Subject: AP1000 COL Technical Report Submittal

1. APP-GW-GLR-005, Rev. 0, "Containment Vessel Design Adjacent to Large Penetrations,"
Technical Report Number 9.

AP1000 Standard Combined License Technical Report

Containment Vessel Design Adjacent to Large Penetrations

Figure 3.8.2-7
Finite Element Model for Large Penetration Local Analyses

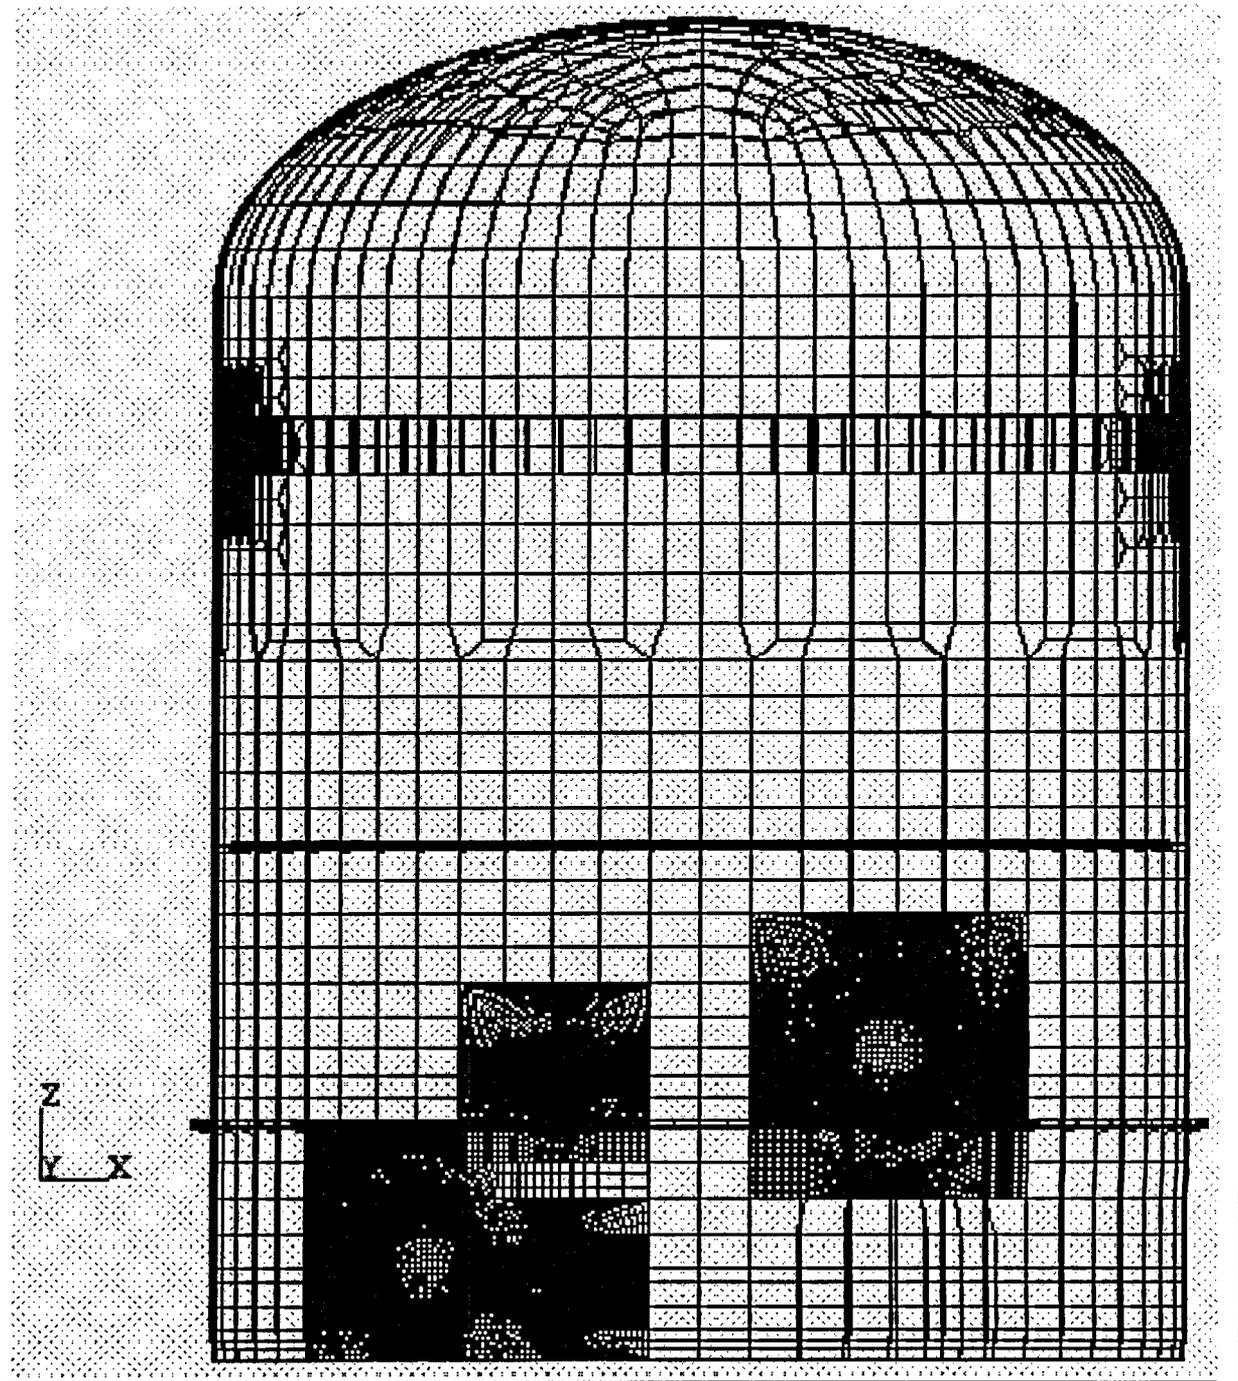
Static analyses are performed using the finite element model shown in Figure 3.8.2-7 for internal pressure, dead load (including the polar crane in the parked position), thermal loads

Replace Figure 3.8.2-7 by the figure below
